**Subject: Beaver Valley Power Station, Unit No. 1
Docket No. 50-334, License No. DPR-66
Generic Letter 88-20 (TAC No. M747378)**

Reference: NRC Letter to Duquesne Light Company (DLC), Beaver Valley Unit No. 1 - Request for Additional Information Concerning Generic Letter 88-20 Individual Plant Examination for Severe Accident Vulnerabilities (TAC No. M74378)

BV1 IPE FRONT-END QUESTIONS

Figure B.2-1. Probability of Nonrecovery of Offsite Power

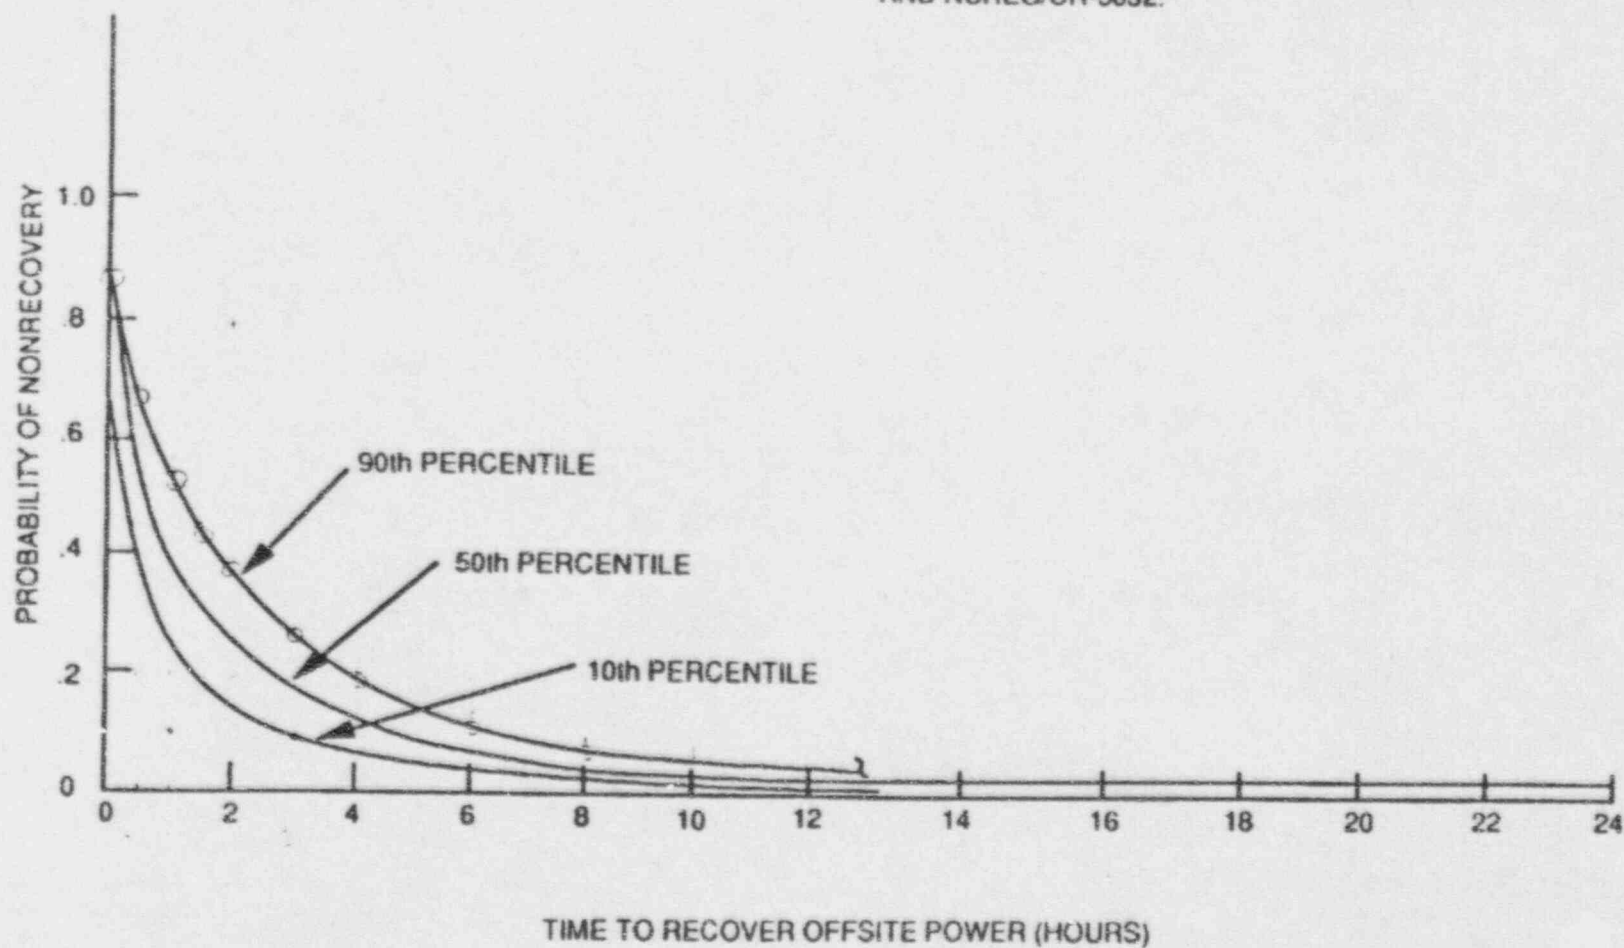
5. NUREG-1335 requests human reliability data, the time available for operator recovery and other generic or plant-specific data for important equipment or events. The submittal does not identify the data used to model recovery of offsite power and recovery of failed Diesel Generators (DGs) which are important recovery actions. Please provide this data and the source of the data.

The electric power recovery model used in the IPE is described in Appendix B, Section B.2., and as stated in response to Front-End Question 1, was not part of the IPE summary submittal. The loss of offsite power data at U.S. nuclear plants reported for all years through 1988 (Reference B.2-1) were the basis for developing the mean probability of nonrecovery of offsite power for PLG's generic database and for use in the Beaver Valley Unit 1 FRA model. Specific line data from the Seabrook site (Reference B.2-2) and South Texas Project site (Reference B.2-3) were used along with data from NUREG/CR-5032 to develop the distributions from the mean for the 10th and 90th percentile cases. These distributions for the probability of nonrecovery used in the electric power recovery model for Beaver Valley are shown in Figure B.2-1, attached. References B.2-1, B.2-2, and B.2-3, respectively, are as follows:

Figure 4.6-7. MAAP Output Curves

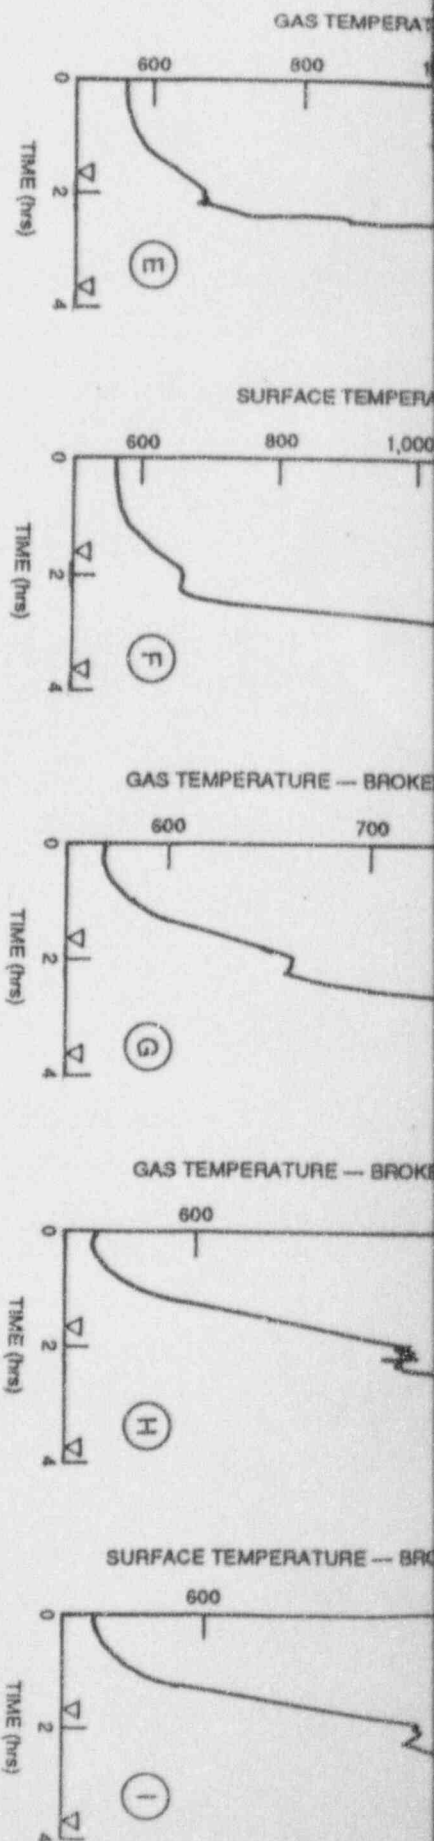
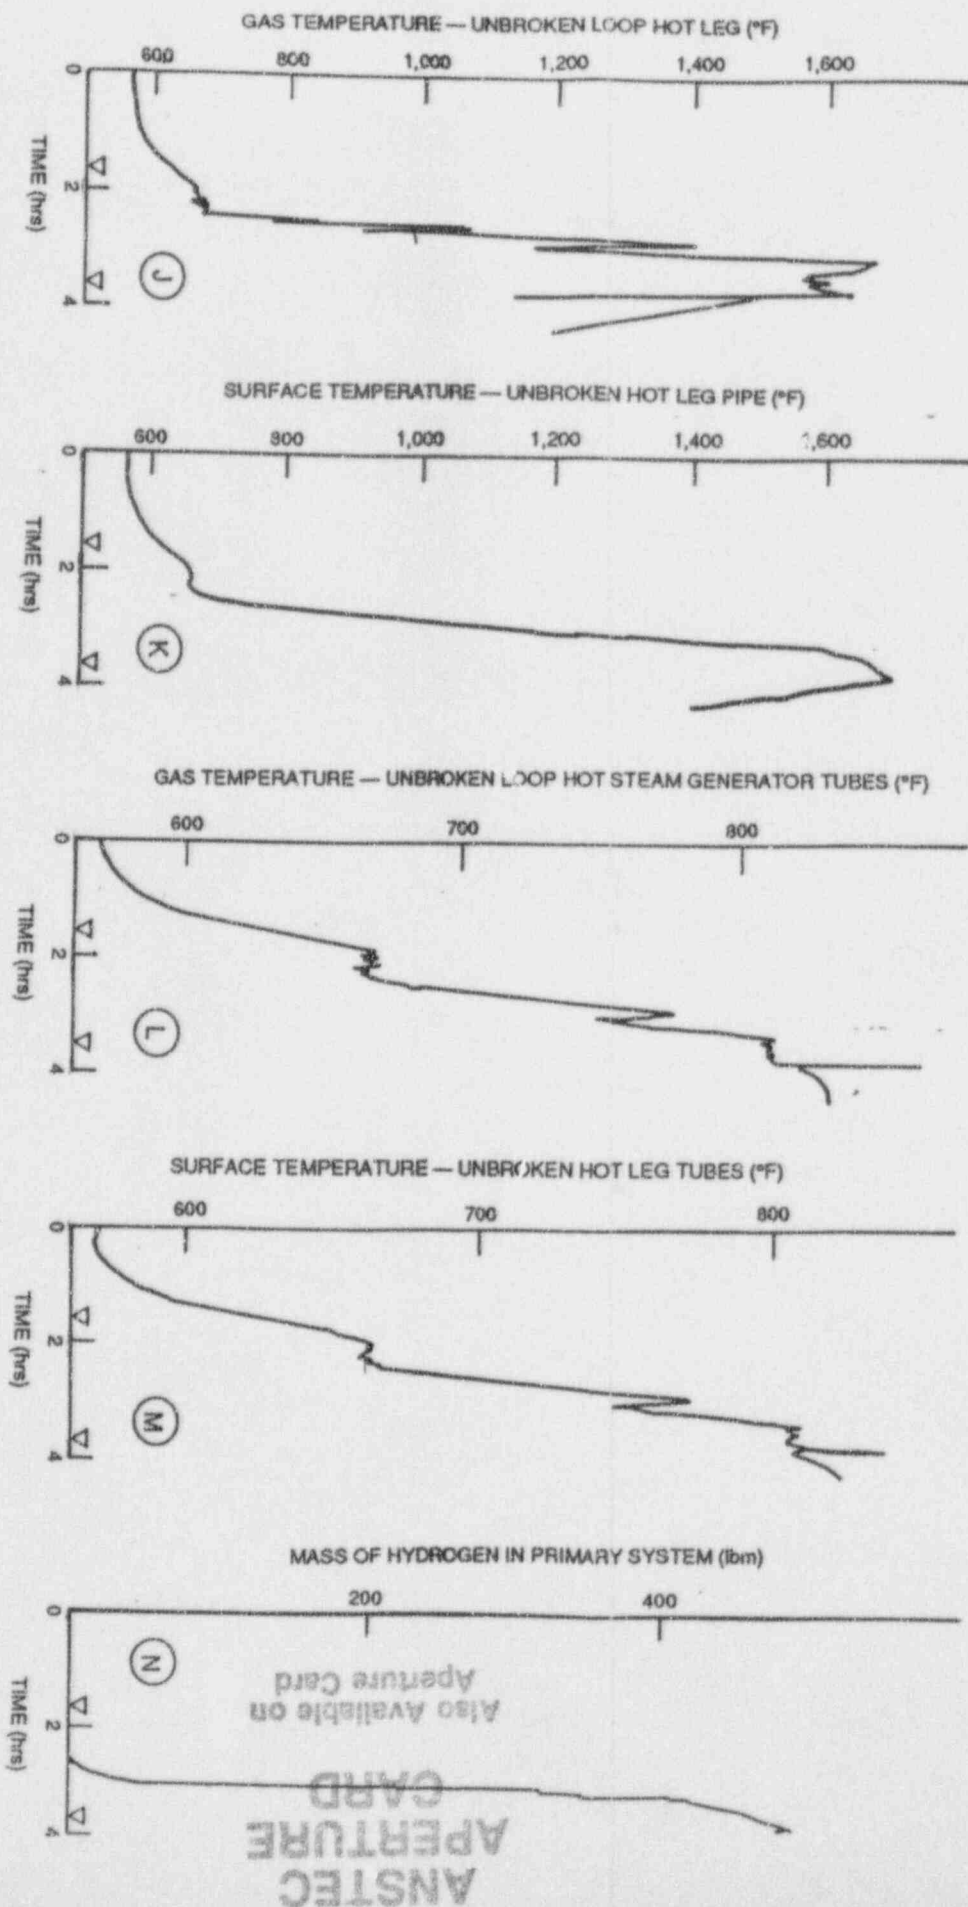
7. Please provide the following:
 - (a) Frequencies of the most significant release categories

See included Figure 4.6-7

FIGURE 5.1-1

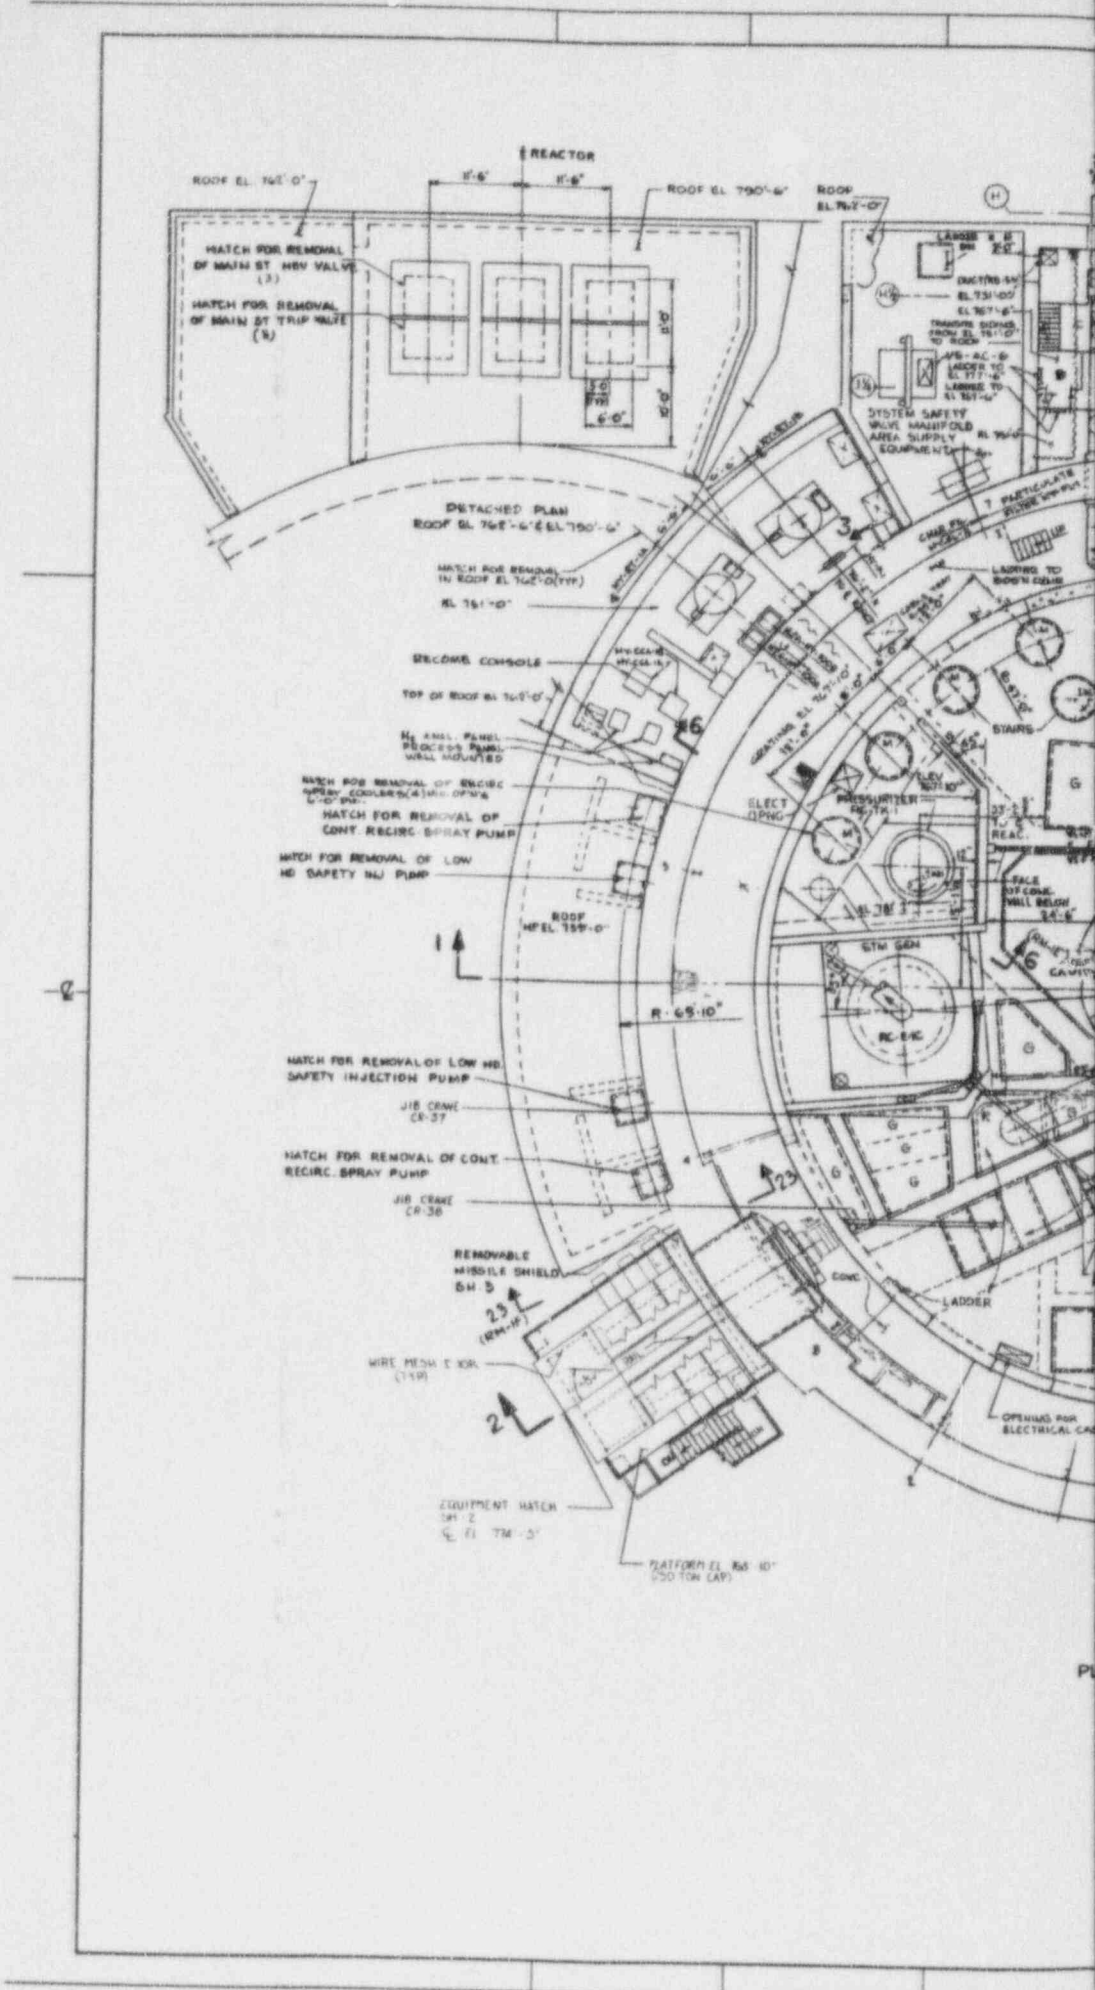
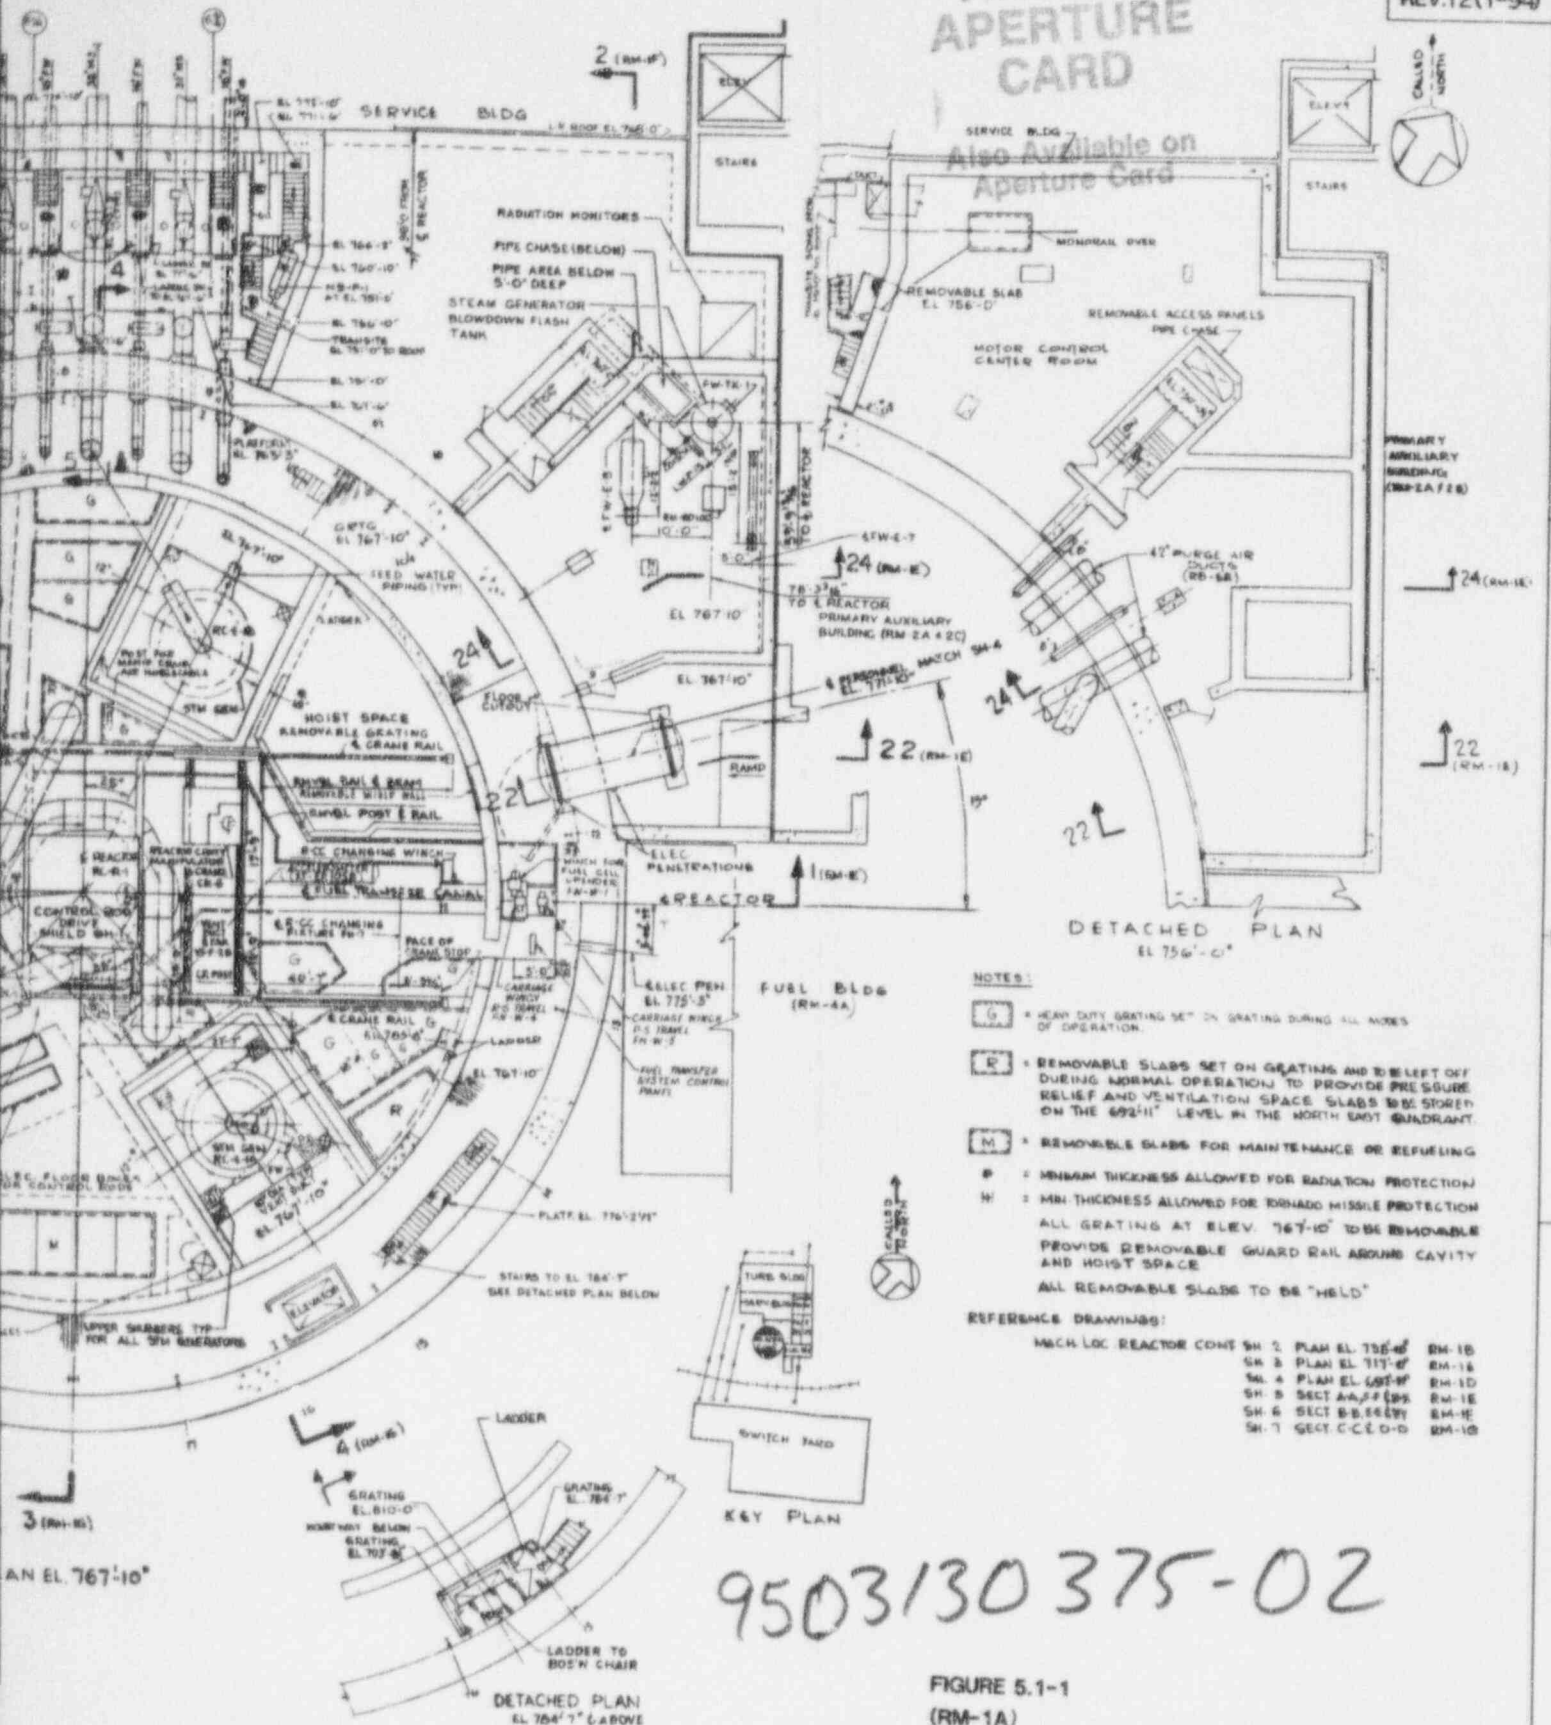
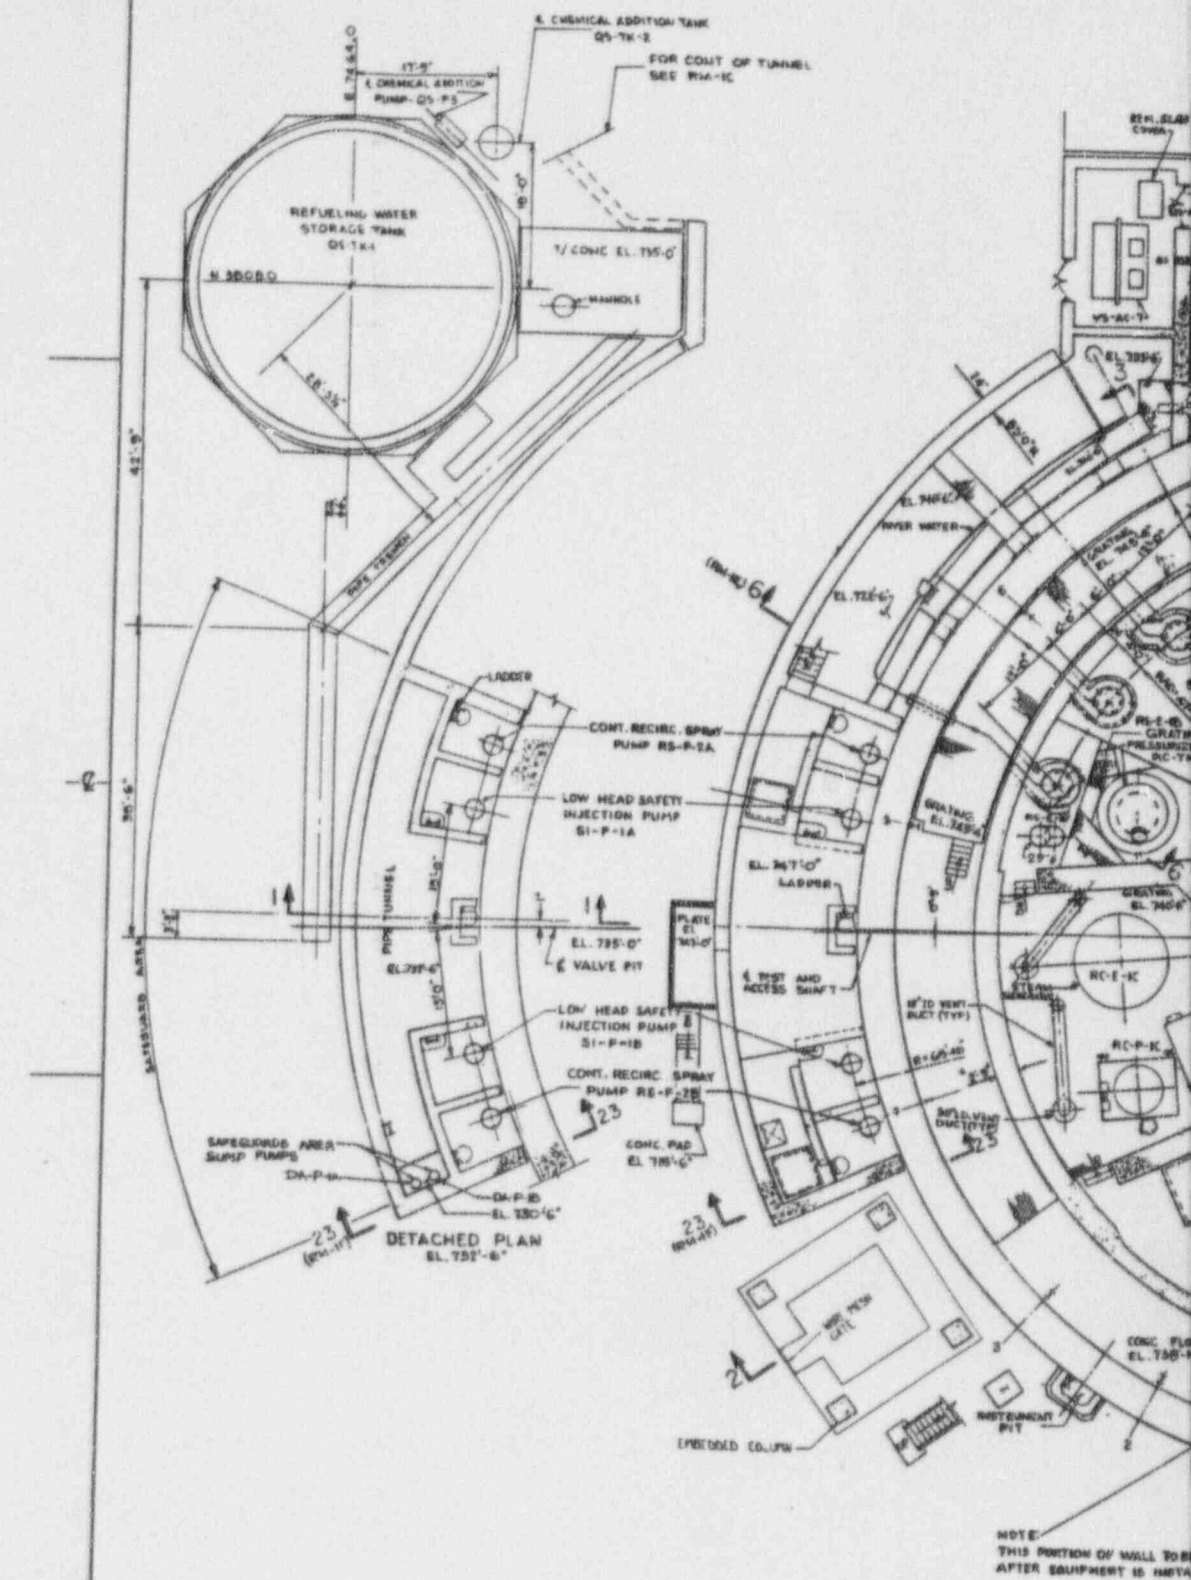
- (c) Drawing of the vessel and reactor cavity showing the shield tanks, the lead shield discussed in the IPE submittal.

See included UFSAR Figures 5.1-1 through 5.1-7.
